REMARKS

Applicant : Mark B. Rosenbluth et al.
Serial No. : 10/024,502
Filed : December 17, 2001
Page : 10 of 10

Amendments to the Drawings:

FIG. 1

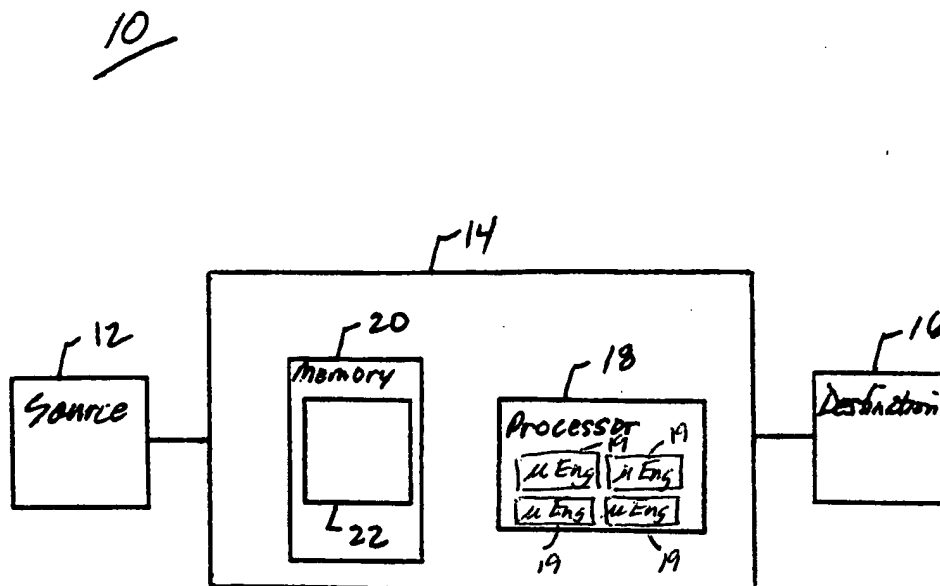
Applicant amended FIG. 1 to include microengines 19. No new matter was added. Support for the amendment is found in the claims as originally filed and in the detailed description on page 3, paragraph starting on line 9.

FIG. 3

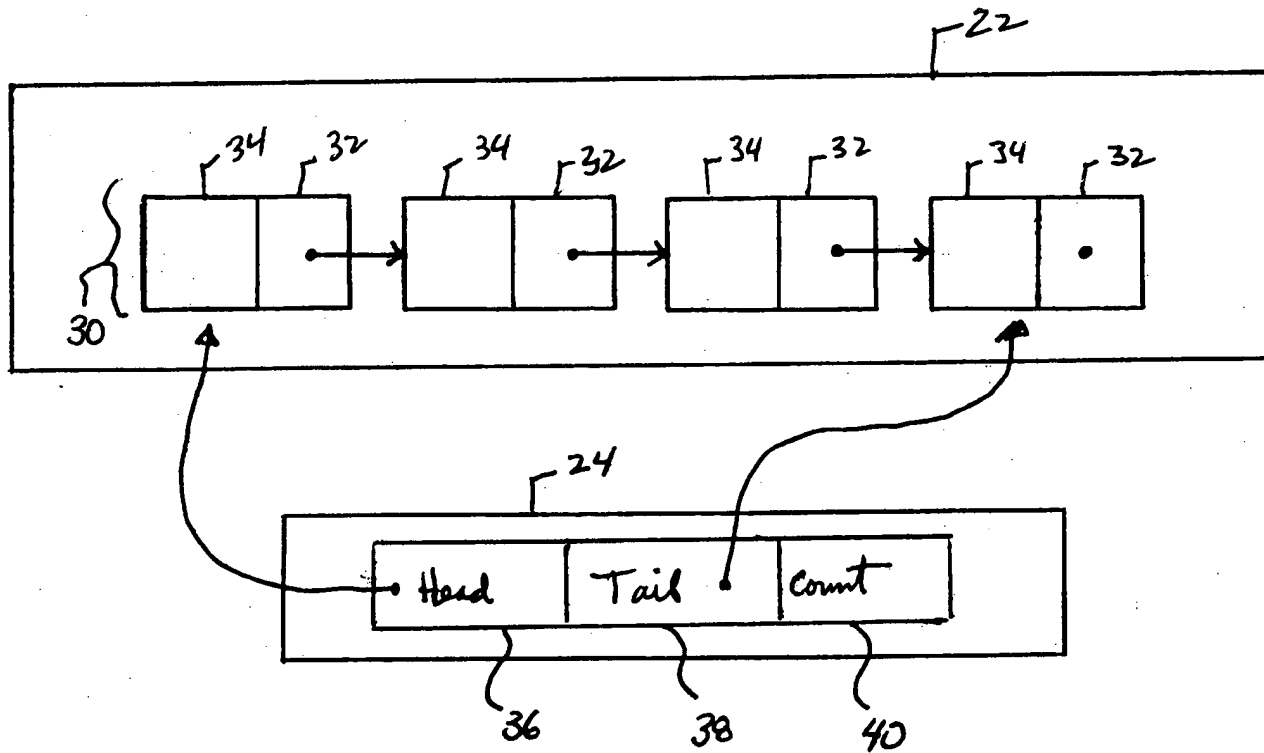
Applicant amended the detailed description with reference to FIG. 3 to correctly indicate that a pointer 32 points to a next element's address 34. No new matter was added.

FIG. 4

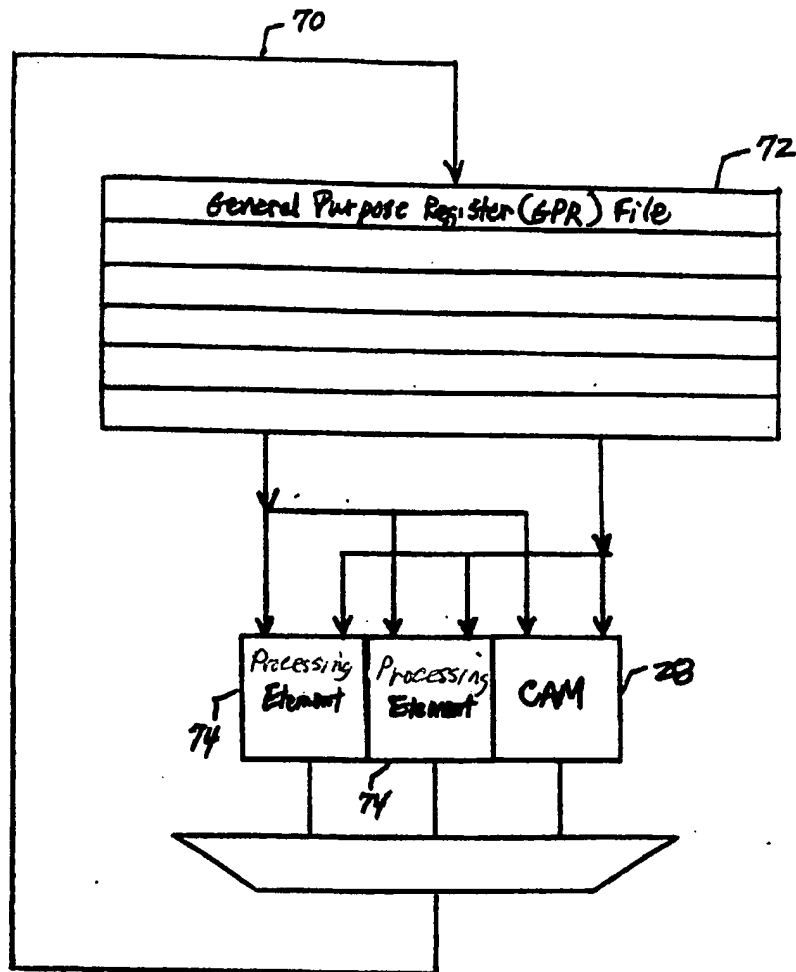
Applicant amended FIG. 4 to properly label processing element 74. No new matter was added.

FIG. 5

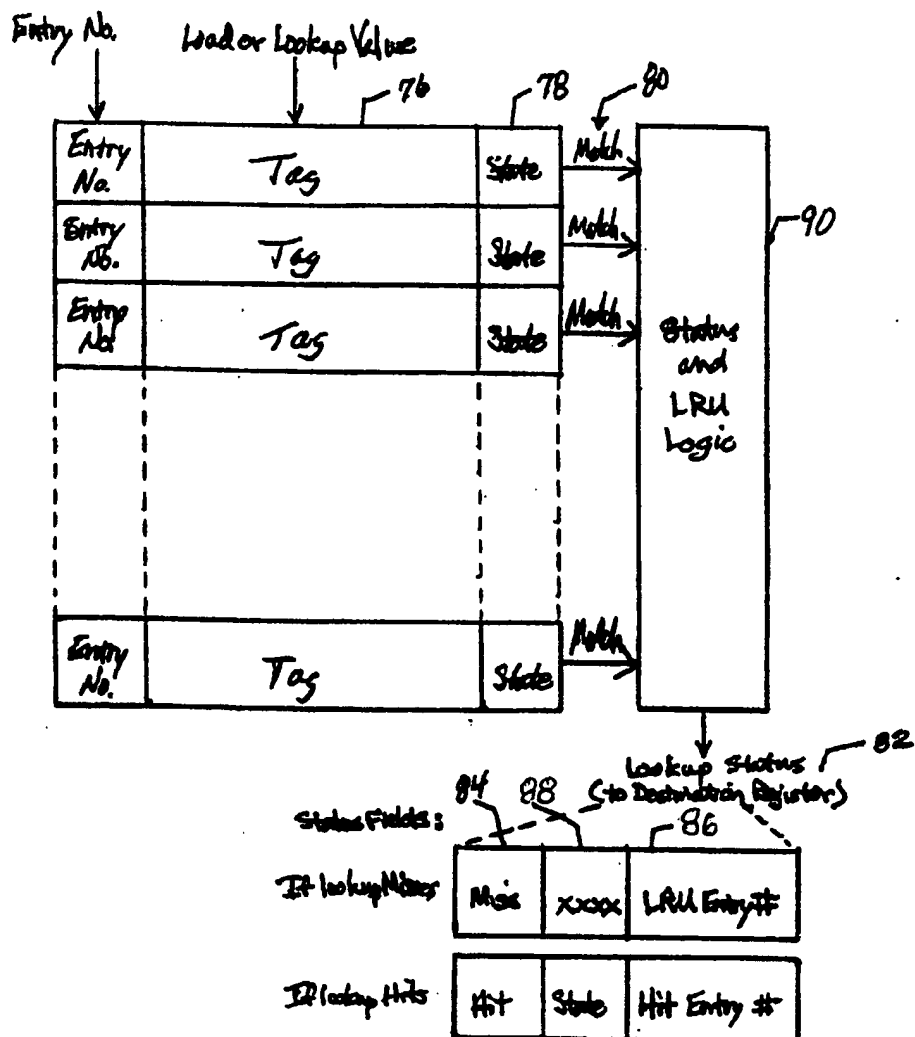
Applicant amended FIG. 5 to correct the typographical errors relating to elements 86 and 88. No new matter was added.
